# CITY OF BRECKENRIDGE, TEXAS TWDB CWSRF WASTEWATER TREATMENT PLANT IMPROVEMENTS PHASE 1 TWDB PROJECT NO. 73905 (CID 01)

#### Addendum No. 2

DESIGNED BY	SCALE	TWDB CWSRF	PROJECT NO.:
Z. MORPHEW	AS NOTED	WWTP IMPROVEMENTS	7902
DRAWN BY		BRECKENRDIGE, TEXAS	7902
B. MCGIFF	DATE		SHEET No.
CHECKED BY	08/19/2025	SLUDGE METER	D-05
B. WHITE

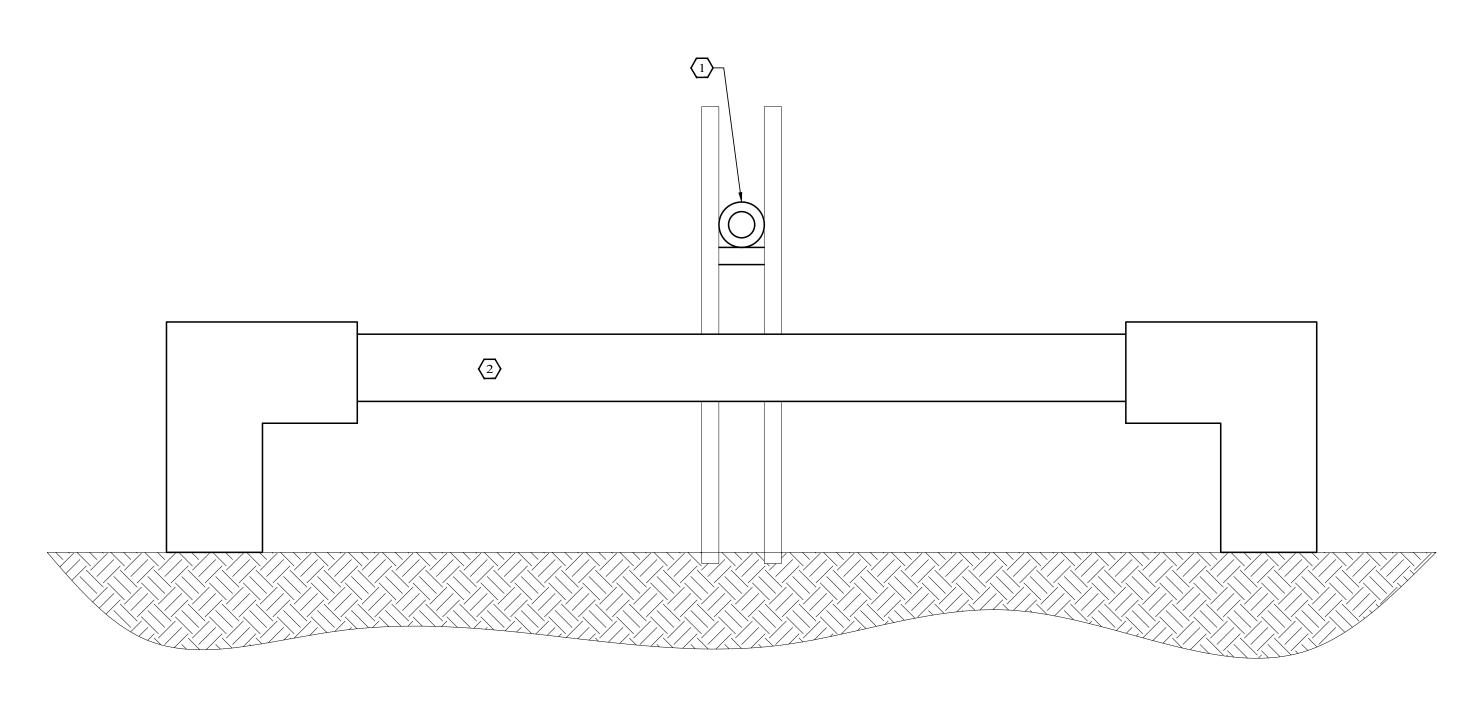
## PROPOSED PIPING REPLACEMENT

- 1. INSTALL PROSONIC FLOW 91W ULTRASONIC FLOW METER. SEE SPECIFICATION 13442.
- 2. INSTALL APPROXIMATELY 20 FT OF ALUMINUM JACKET INSULATION ON THE EXISTING 6-INCH DUCTILE IRON PIPING. SEE SPECIFICATION 15180.
